WATER PERMIT NO. 6056-3

Application For Permit To Appropriate Water Within The State Of South Dakota

REPORT ON
WATER PERMIT APPLICATION No. 6056-3
Lynn Brandenburger
March 30, 1998

SKETCH PLAN OF DAM AND RESERVOIR AREA

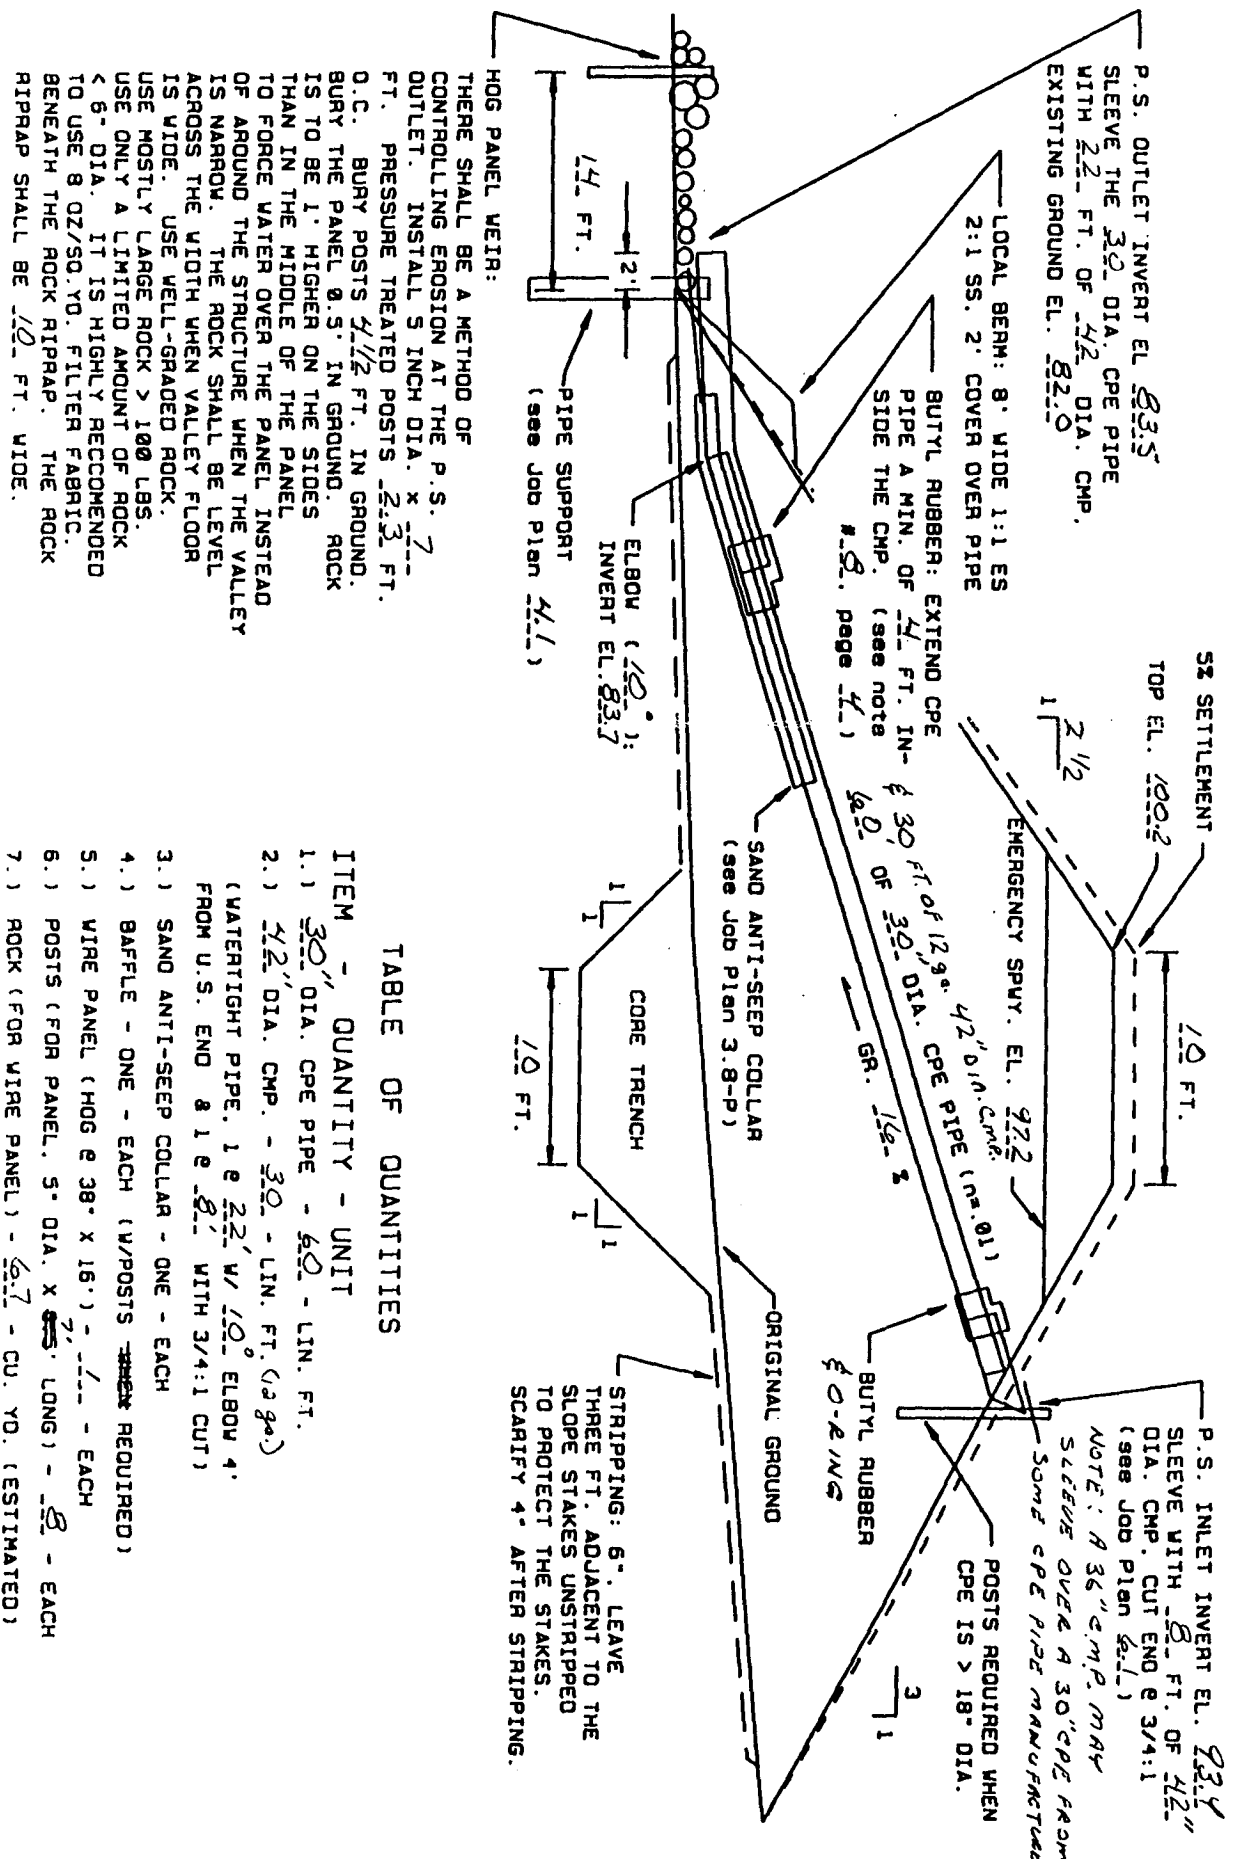
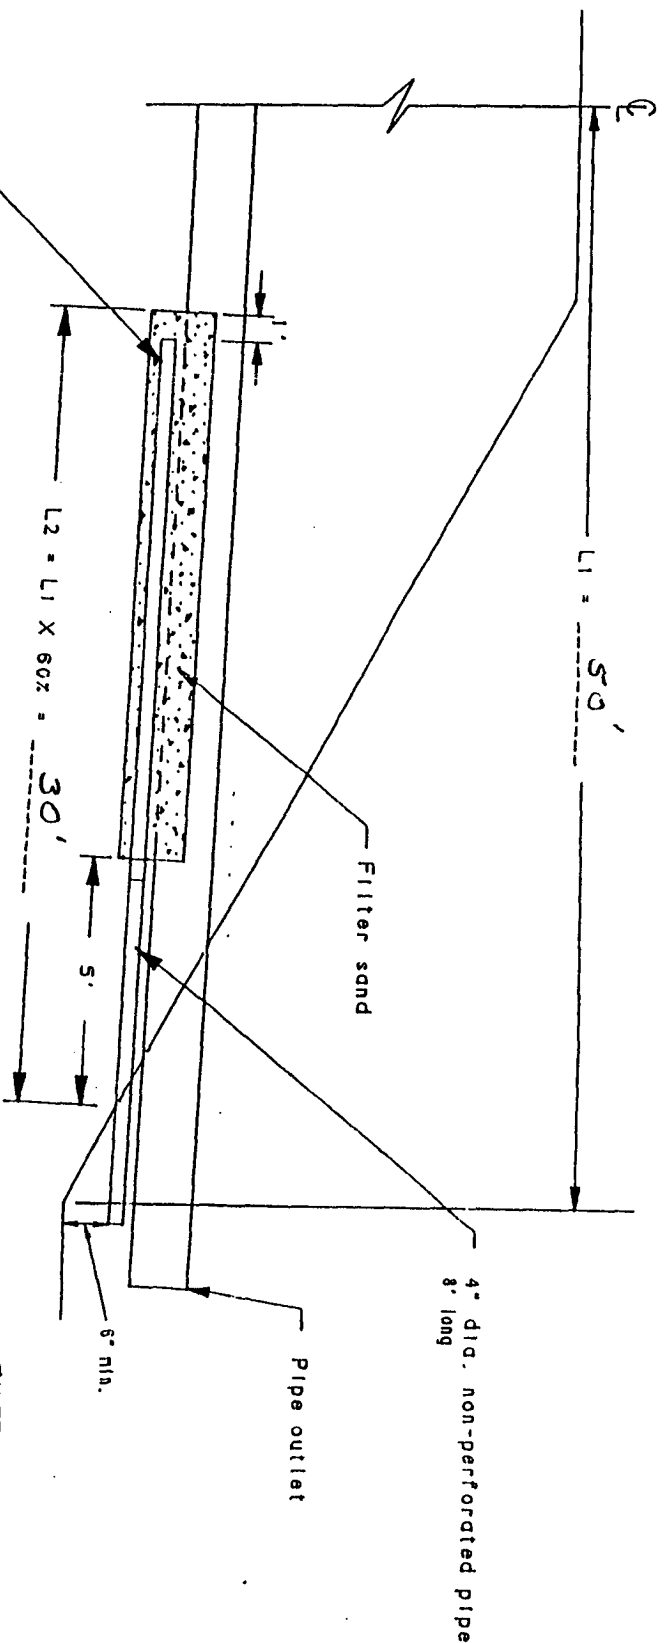
1) Topo Map - OK

2) Dam X-Section - OK

3) Dam X-Section - OK

4) Area/Capacity Data - OK

5) Outlet Detail - OK

6) Spillway Rating - OK

7) Spillway Details - OK

We have reviewed the plans and specifications for your proposed dam to be located in the W ½ of Section 3-T127N-R50W, in Roberts County. The plans and specifications as submitted are approved. Approval of the plans and specifications does not authorize construction of the project. Construction of the project may not begin until Water Permit Application No. 6056-3 is approved.
